Addendum No. 3

RE: Contract ID C203171

Dare County (B-2500A)

Long Term Improvements (Phase II) To Pea Island On NC-12

ANTICIPATED TESTING / END ANCHORAGE

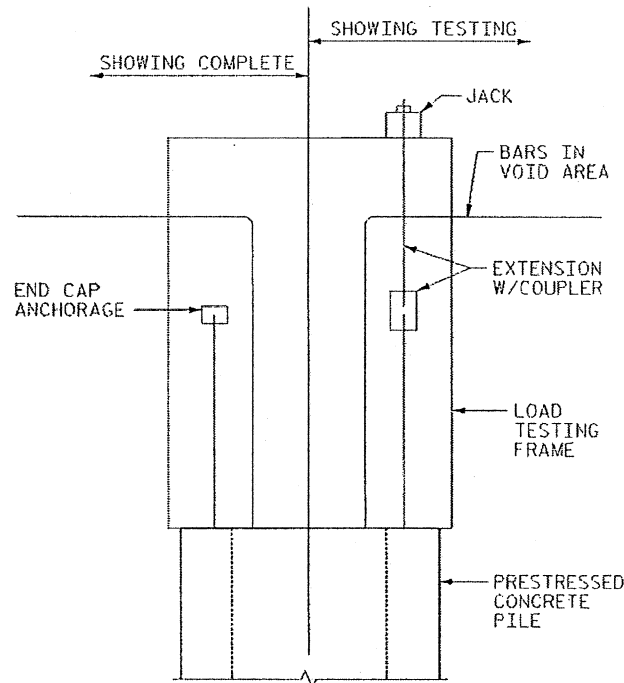
Dowels installed after driving will be tested for level 2 field testing. Dowels will be tested on a per footing basis and shall be located on a single pile where possible. Prior to testing, hollow core reinforcing steel shall be installed and pile voids shall be poured with concrete up to the top of the pile. No other pile dowels are to be installed in the footing until test dowels have been installed, tested and approved. The contractor shall devise a method for testing dowels per the conditions noted above by either constructing a test frame above the hooked hollow core bars, by use of mechanical couplers or by use of any sound methodology to accomplish load testing of the dowel bars. The contractor may eliminate the hooks on the dowel bars to be tested if a mechanical end anchorage is installed in lieu of the hooks. The end anchorage shall be a manufactured device approved for use in the proposed configuration. The contractor may temporarily extend the dowels to a vertical height above the reinforcing steel projecting from the pile to facilitate testing. See sketch below for clarification of anticipated concept.
